MODIFICATIONS TO THE TUBE-LAUNCHED, OPTICALLY
TRACKED, WIRE-COMMAND MISSILE LAUNCHER FOR
THE BRADLEY FIGHTING VEHICLE SYSTEM

Report Number 98-165

June 25, 1998

Office of the Inspector General
Department of Defense

Figure 2. Switch Adjustment Gauge Set

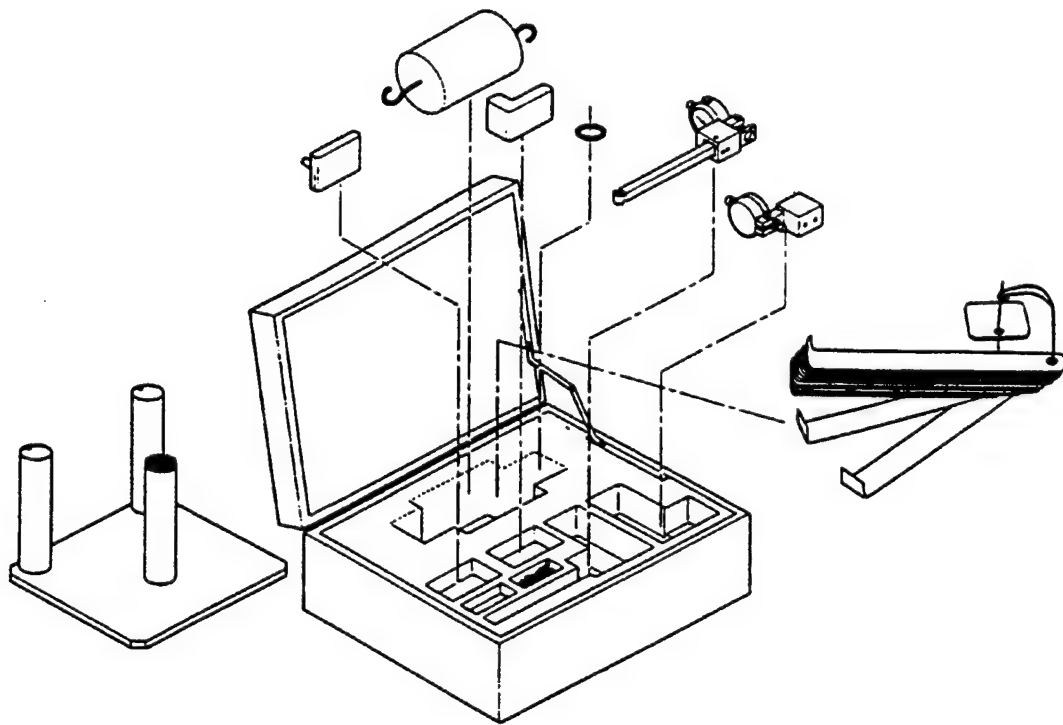
ACU Final Assembly and Testing. Final assembly and testing of the ACU requires a switch adjustment gauge set, part 1366078, to ensure proper alignment of the ACU. The gauge set comprises gauge assemblies, tools, and fixtures as shown in Figure 2.

The gauge set is used to align and test umbilical and motor stop switches within the ACU. Those switches must be set to precise tolerances to satisfy design specifications and meet minimum in-process quality assurance inspection points required by the DMWR.

Figure 3. Umbilical Switch Specification

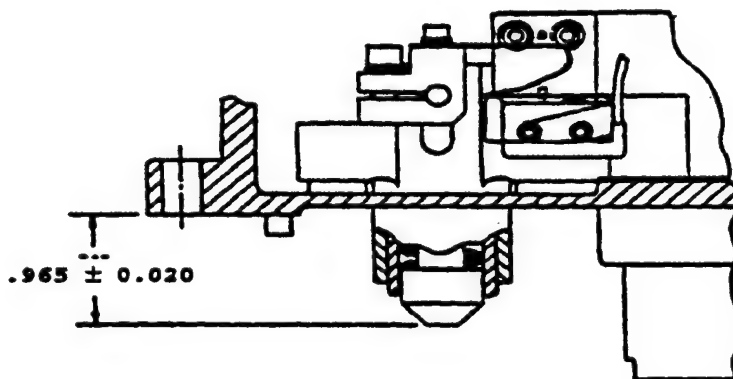
Alignment of Umbilical Switches. The DMWR requires the gauge set to align and test the ACU umbilical switches S1, S2, S3, and S4. Switches S1 and S2 are associated with the inboard launcher tube, while S3 and S4 are associated with the outboard launcher tube. The S2 and S4 switches, when activated, signal that a missile is present. The S1 and S3 switches, when activated, signal that a missile has been selected. According to the design specifications, those umbilical switches should be aligned to activate when the bottom of the holdback pin plunger is 0.965 inches, plus or minus 0.020 inches, from the bottom of the ACU housing as shown in Figure 3.

The S1 through S4 gauge assembly of the gauge set is used to measure the depth of the holdback pin plunger at the time the umbilical switches have been activated.

Figure 4. Holdback Pin Plunger Depth Specification

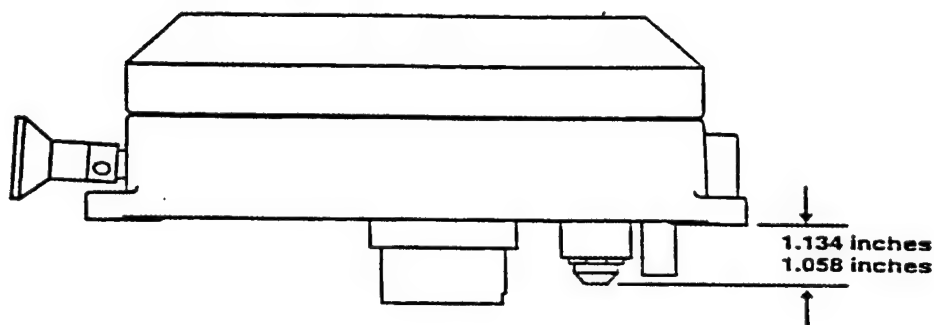
Alignment of Motor Stop Switches. The DMWR requires the gauge set to align and test motor stop switches S5 and S6. The S5 switch is the electrical limit switch for the extend function of the ACU motor. The S6 switch is the electrical limit switch for the retract function of the ACU motor. The S5 and S6 settings affect the distance that the holdback pin plunger and umbilical cable are extended when arming the system and retracted when disarming the system. The gauge set, specifically the S5 gauge assembly is required to ensure that the holdback pin plunger depth in relation to the ACU housing is between 1.058 inches and 1.134 inches, as shown in Figure 4, in order to satisfy design specifications.

Figure 5. Setscrew Adjustment Gauge

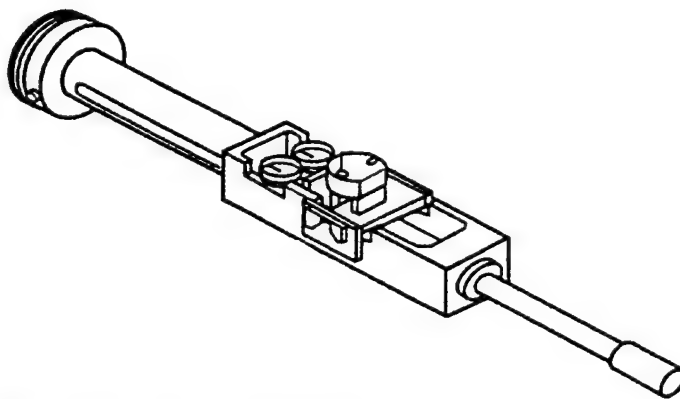
Setscrew and Stop Block Adjustments. A setscrew adjustment gauge, part 12295912-40101-5 (shown in Figure 5), is required to perform the setscrew

and stop block adjustments to ensure that they meet the design specifications. The setscrew is to be set between -0.0005 inches and 0.0005 inches; and the stop block is to be set between 0.002 inches and 0.001 inches.
